Huawei Technologies Co., Ltd.

Request for Permissive Change Class II
FCC ID: QISM210

Pursuant to CFR § 2.1043, Huawei Technologies Co., Ltd. hereby requests a Permissive Change Class II for its application with FCC ID: QISM210 granted on 2013-05-19

1.

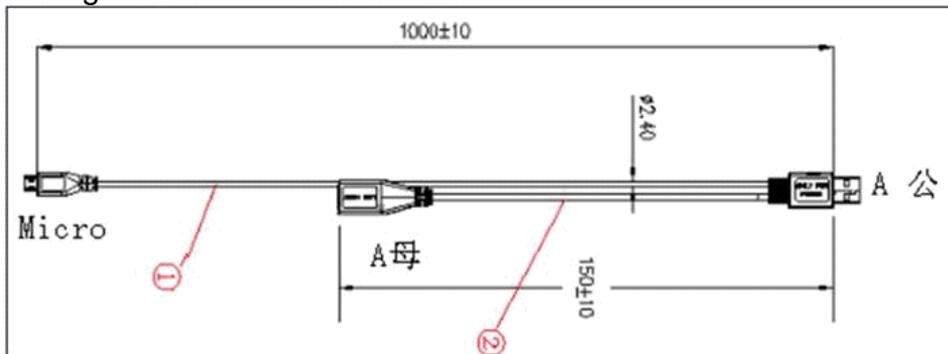
1. Change the USB Cable to the USB Cable with OTG USB Port (see appendix 1)
2. Change of PCB layout (add the Q1 part and peripherals circuits for improve that when the product halted and can automatically restart) (see appendix 2)
3. Change of the adaptor
4. Other hardware are the same
